Oct. 23, 2017

Process Change Notice - Solera Smart Arm Awning and Power Awning wiring

Fig.1
Solera Smart Arm Wiring Diagram

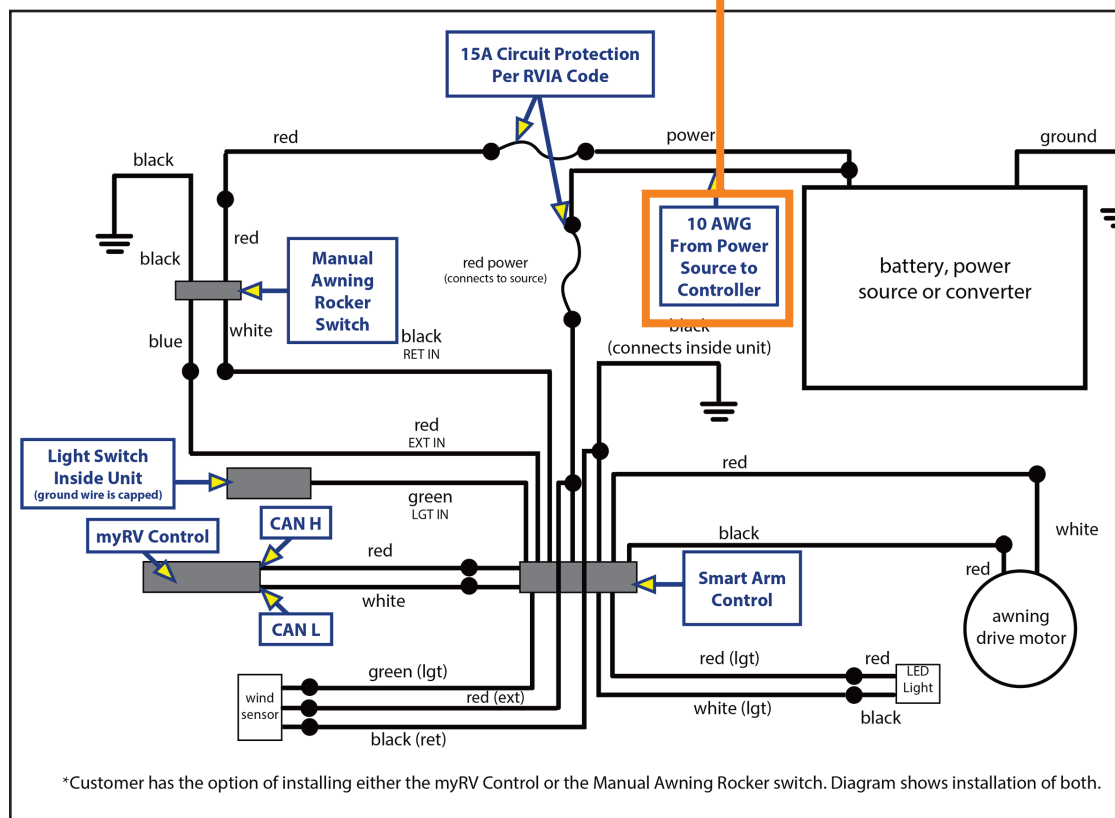
The minimum voltage for both awnings has changed from 12V to 11.5V minimum. The wire gauge requirement has also changed on the Smart Arm only from 10 AWG to 12 AWG (Fig.1). The gauge requirement of the Solera Power Awning was already smaller at 14 AWG (Fig. 2).

**12 AWG min. from
Power Source to Con-
troller; 11.5V min.**

Fig.2

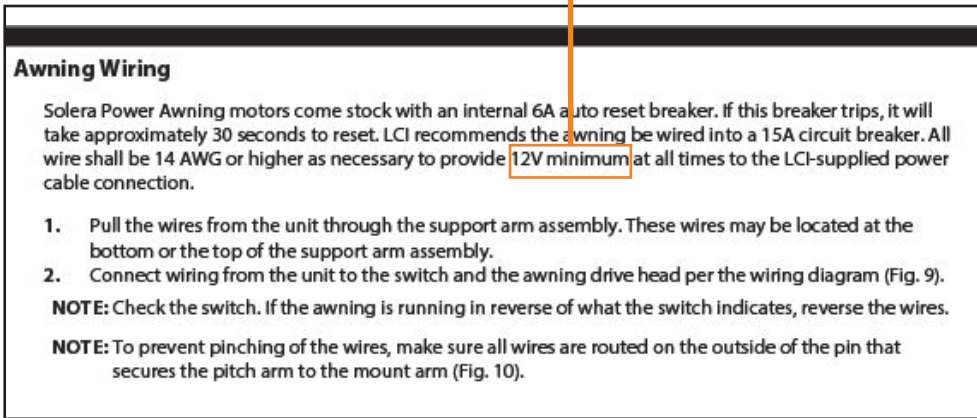
All wire shall be 14 AWG or higher as necessary to provide 11.5V minimum at all times to the LCI-supplied power cable connection.
